Drawing Amendments

Remarks

Please amend Fig. 5 of the drawings as shown in red below:

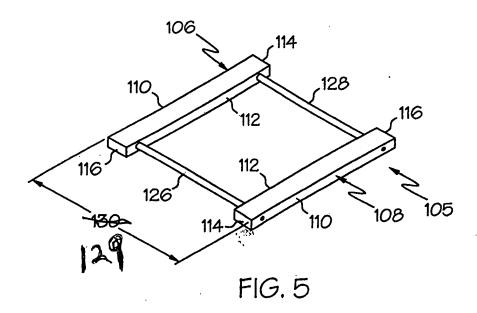
The drawings have been amended. The specification describes two elements bearing indicia number 130 and therefore Fig. 5 has been amended to change the indicia number for the spacings between the outer ends of the paddles from 130 to 129, to thereby eliminate the double use of the indicia number 130.
